**Supplemental Comments on U.S. Environmental Protection  
Agency Region 6 Proposed Remedial Action Plan for the  
San Jacinto Waste Pits Superfund Site  
Considering Hurricane Harvey**

Michael R. Palermo, PhD, PE  
Mike Palermo Consulting, Inc.  
10030 Green Level Church Rd, Ste 802-1280  
Cary, NC 27519-8168

October 6, 2017

Figure 1. Photos of localized displacement of armor stones following Hurricane Harvey event.

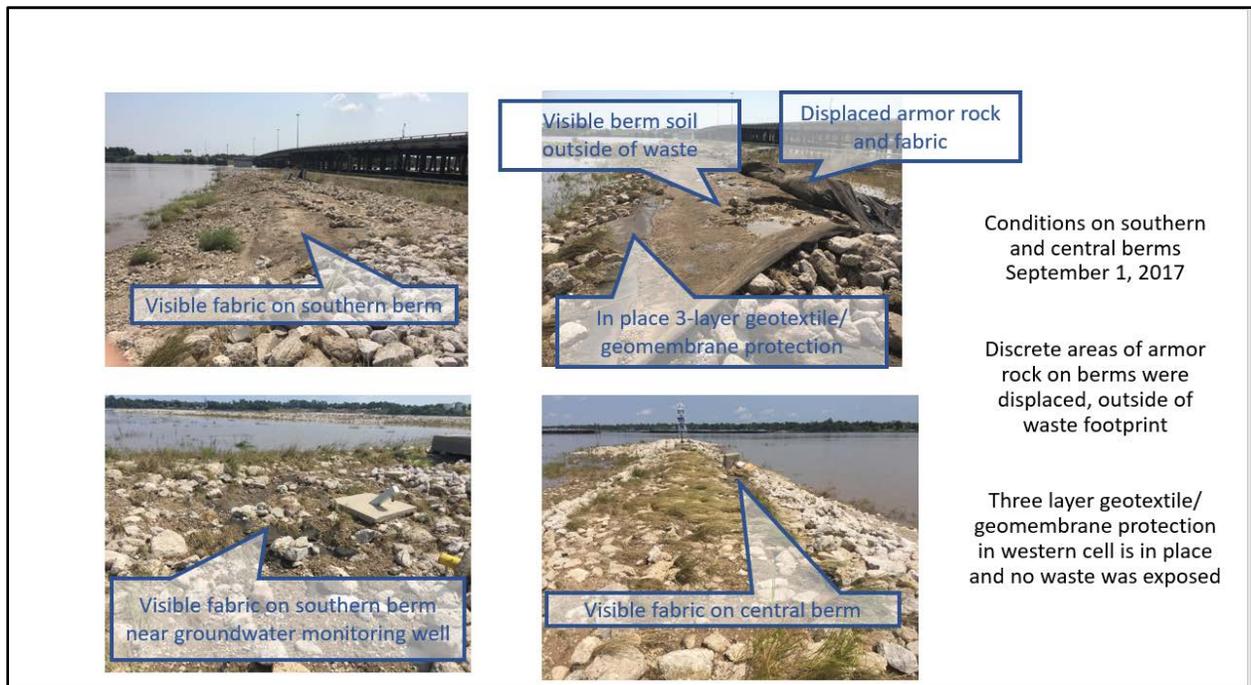
Figure 1 is a collage of photos showing areas of the TCRA cap where armor stone movement occurred as a result of the Hurricane Harvey event. These photos, taken on the Western Cell, show armor stones were moved, primarily in limited areas on the raised geometry of the perimeter berm surrounding the Western Cell. The photos also clearly show that the underlying 3-layer geotextile/geomembrane that covers the waste within the Western Cell remained intact in these areas even in instances in which the surface geotextile was exposed or moved. A key result of the post-Hurricane Harvey surveys is that areas of armor stone movement were very limited in extent.

Figure 2. Post-Dive Survey Inspection Areas of Interest (AOI) (from Anchor QEA 2017a).

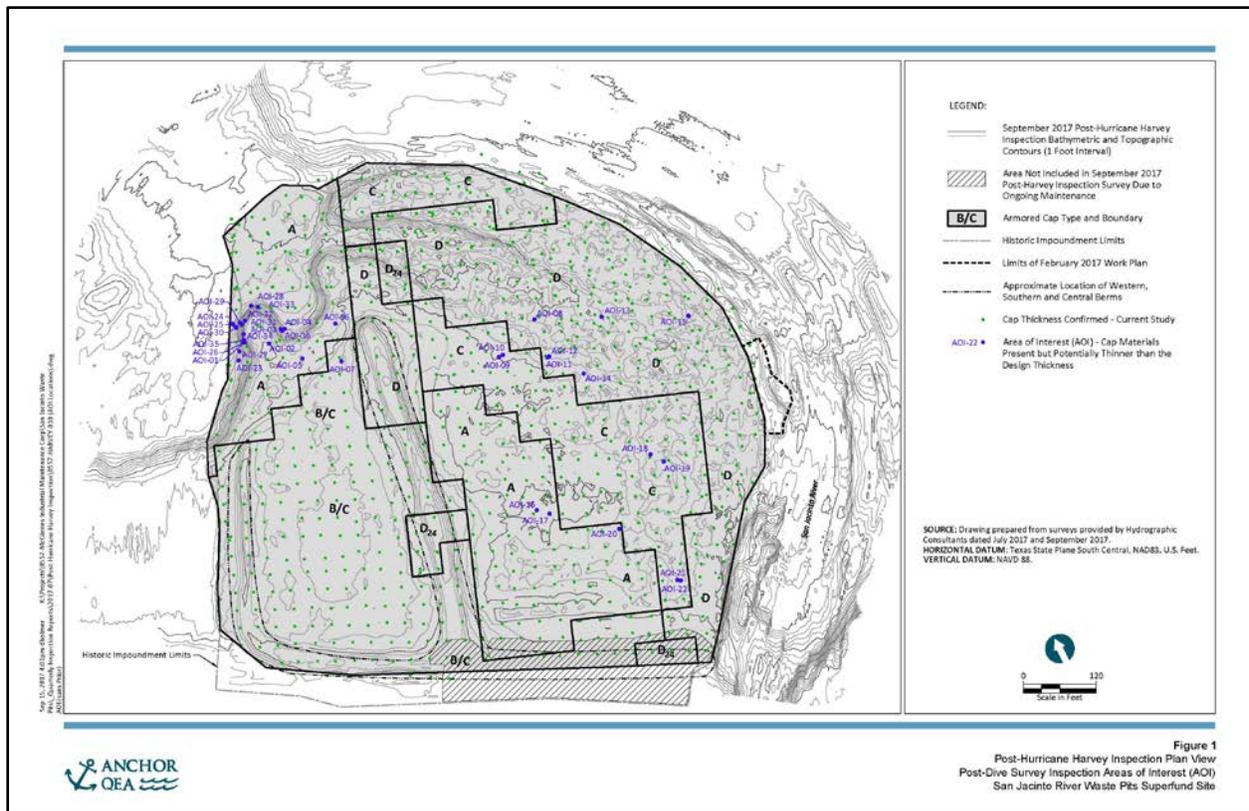
Figure 2 is a map showing the results of the visual and probing surveys taken by Anchor QEA post-Hurricane Harvey to determine cap armor stone thickness. The green dots show stations where the design cap thickness was confirmed. The map of the TCRA cap area is practically all green. The “areas of interest” are shown as blue dots and are labeled. The blue dots are widely scattered specks over the TCRA cap area, but there is a concentration of areas of interest on the northwestern perimeter of the cap. All these areas of interest were found to have armor stone still in place, but at thickness potentially less than the design thickness. The combined surface area of all the areas of interest was approximately 195 square feet, or less than 0.03 percent of the surface area of the TCRA cap. There was no evidence of a release of waste from any of these areas. (Anchor QEA 2017a). Within days following the Hurricane Harvey event, maintenance was performed in all areas of interest with armor stone thickness that could not be confirmed to be at the design thickness, using 10-inch mean diameter stone.

These survey results are indicative of the margin of safety in the design process for cap armor. The TCRA cap armor, intended as a temporary measure, was designed to protect against a 100-year event, with 3 to 10-inch mean diameter stone sizes. The basis of an armor design is to select a stone size to resist stresses that would merely induce movement of the stone, not wash the stone armor layer away. Hurricane Harvey, characterized as a 500-year event, was much stronger than the 100-year design event and did in fact move armor stones in limited areas. Yet, the TCRA cap remained intact, providing stability against the forces generated by Hurricane Harvey.

Figure 4. Map showing elevation changes at the TCRA Site resulting from Hurricane Harvey (from Anchor QEA 2017b).

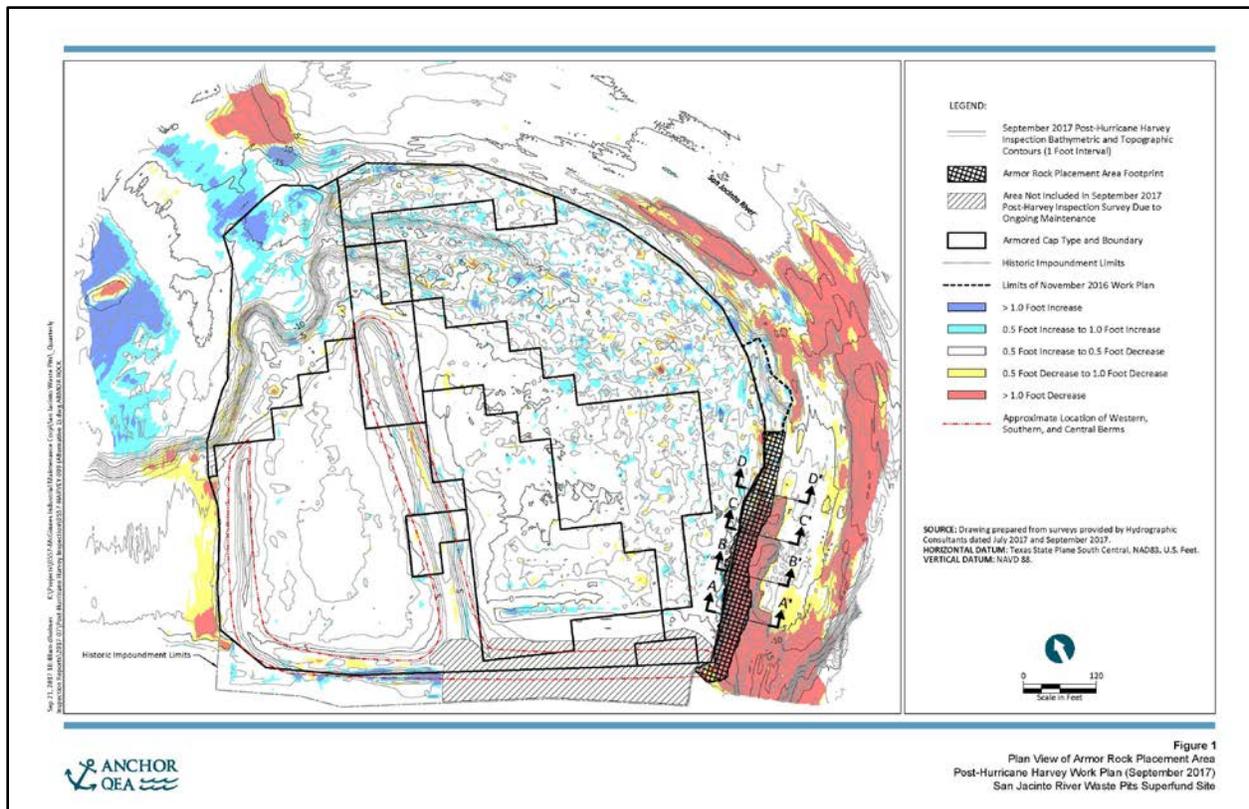
Anchor QEA conducted a topographic and bathymetric survey of the Site and surrounding area and compared the results with pre-Hurricane Harvey results. Results of these surveys are mapped in Figure 4. The blue and white shading indicates areas with increases in surface elevation or no change in elevation. The yellow and orange shading indicates areas with reductions in elevation, indicative of scour due to Hurricane Harvey. With the exception of very small areas, the entire surface of the TCRA cap shows no decrease in elevation, demonstrating that the TCRA cap remained stable.

Areas outside of and around the periphery of the TCRA cap are not armored. The cross sections accompanying the map show areas immediately adjacent to the TCRA cap with significant elevation decreases indicating scour had occurred. Areas of particular concern include the area immediately adjacent to the eastern edge of the TCRA cap and the area at the prominent feature at the northwest edge of the cap (this is the same area with multiple small “areas of interest” with reduced cap thickness that the EPA dive team focused its sediment sampling effort).

This observed scouring does not indicate a potential issue with the stability of either the TCRA cap itself or of the Alternative 3aN enhanced cap. The caps themselves are armored. But clearly, these results in non-armored areas indicate the need to address the areas adjacent to the cap boundary to avoid potential undermining of the armored cap. Such an enhancement of the Alternative 3aN enhanced cap was mentioned in both the USACE report and in my earlier comments on the PRAP. This can be accomplished by flattening the cap slopes to extend the armor stone protection beyond the present limits of the TCRA cap. Anchor QEA has prepared conceptual drawings showing the flattened slopes as shown in Figure 5. Additional protection could be provided by including an armor stone toe berm at the edge of the cap. These enhancements to the design of the Alternative 3aN cap would avoid potential undermining of the cap.
